## **REMARKS**

The instant application is directed to a method of manufacturing a distributed analog phase shifter, the method comprising, depositing a ferroelectric film on a substrate, etching the ferroelectric film to form ferroelectric patterns, depositing a metal layer on the substrate on which the ferroelectric patterns are formed; and forming a coplanar waveguide, first electrodes, a ground line, and second electrodes by etching the metal layer covering the ferroelectric patterns, wherein the first electrodes and the second electrodes are formed such that portions of the first electrodes and second electrodes overlap with the ferroelectric pattern, respectively.

### **II. Drawing Objection**

FIG. 4A

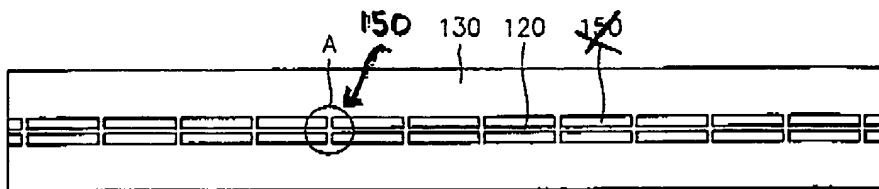
In the outstanding Action, the Examiner objects to the drawings for failing to comply with 37 CFR 1.84(p)(4) alleging reference character "150" is used to designate the indigitated capacitor ("IDC") shown in Figure 4C whereas in Figure 4A "150" does not point to the IDC of Figure 4C. The Examiner further alleges in Figure 4A, the reference number "150" points to a region outside of Figure 4B. Applicants respectfully submit herewith corrected drawing sheets in compliance with 37 CFR 1.121(d) and marked up drawings in which reference number "150" has

been corrected to refer to the correct grouping of components. In view of the foregoing, Applicants respectfully request reconsideration and withdrawal of the objection to the drawings on this basis.
